MAXIMUM SERVICE TELEVISION

Re: OET Testing of Unlicensed Devices; ET Docket No. 04-186

# Proposed Modifications/Additions to the Tests Conducted by the FCC to Evaluate the Performance of Prototype TV-Band White Space Devices

# Deficiencies in the OET Test Plan to Evaluate the Performance of Prototype TV-Band White Space Devices

*Microsoft TV White Spaces Development Platform Version 2*

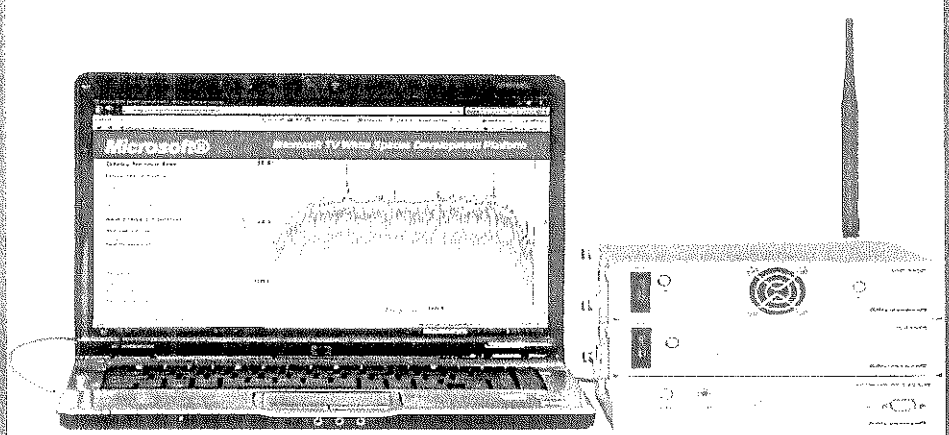
- Two devices were submitted same as previous devices
- Different antenna
  - Center loaded whip
- Sensing Capability
- Transmit capability
  - Includes separate outboard "brick" filter

# Motorola Device

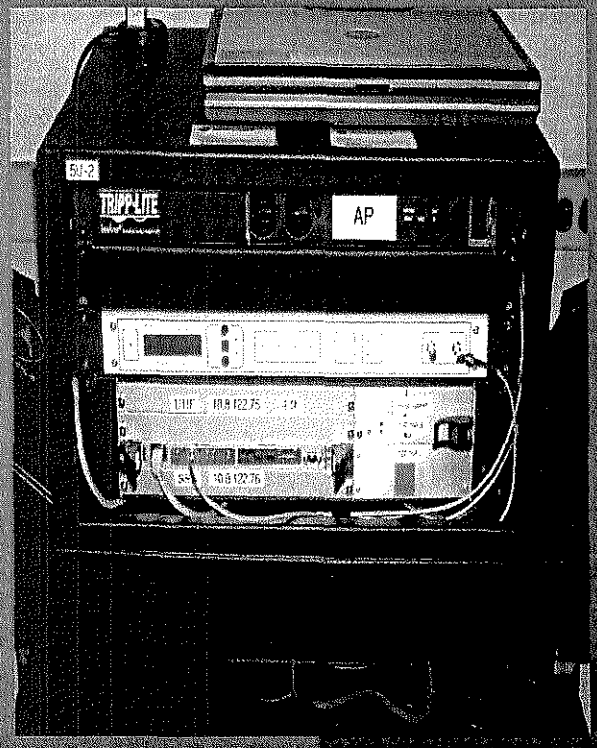
- Introduces the concept of geo-location database enabled WSDs.
- Hybrid devices uses:
  - GPS/Geo-location database
  - Spectral sensing for mobile
- Transmitter disabled
- Device operates on adjacent channel
- Additional "sensing only" mobile component not pictured or submitted for testing

Figure 1: I²R white-space sensing device

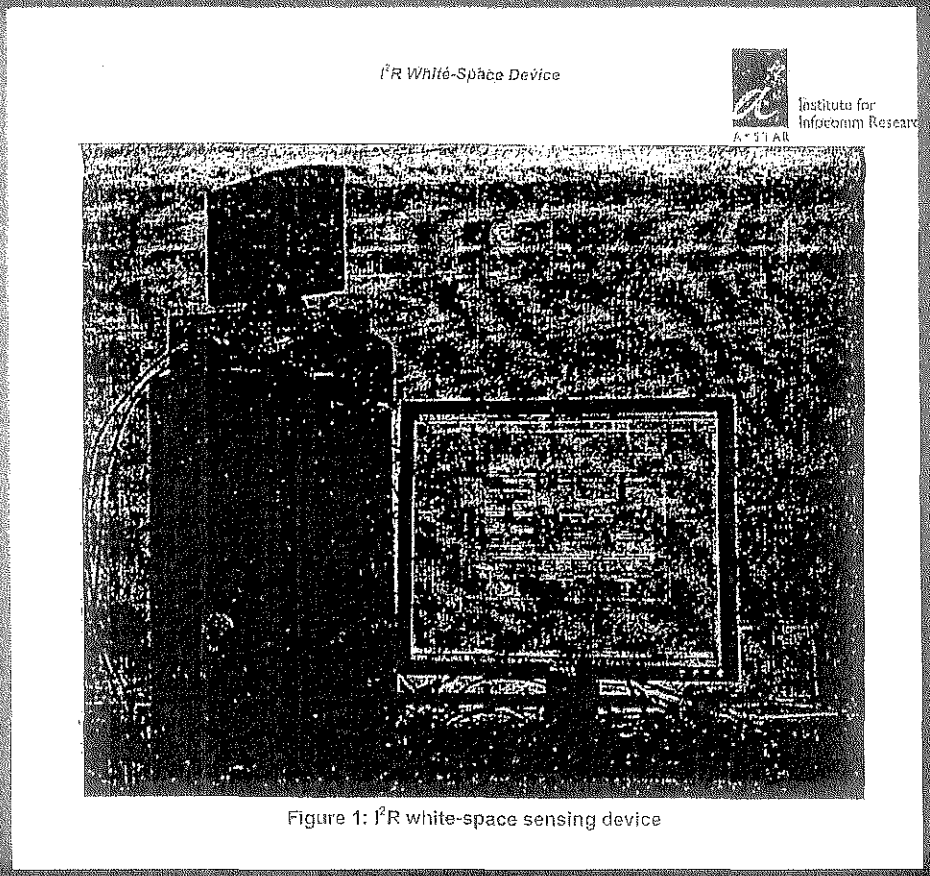
- Institute for Infocomm Research (I²R) of Singapore
- Will submit 2 identical devices
- Key Components
  - Omni antenna
  - Commercial TV tuner from Freescale
  - Mixed signal and digital processing boards
  - Computer
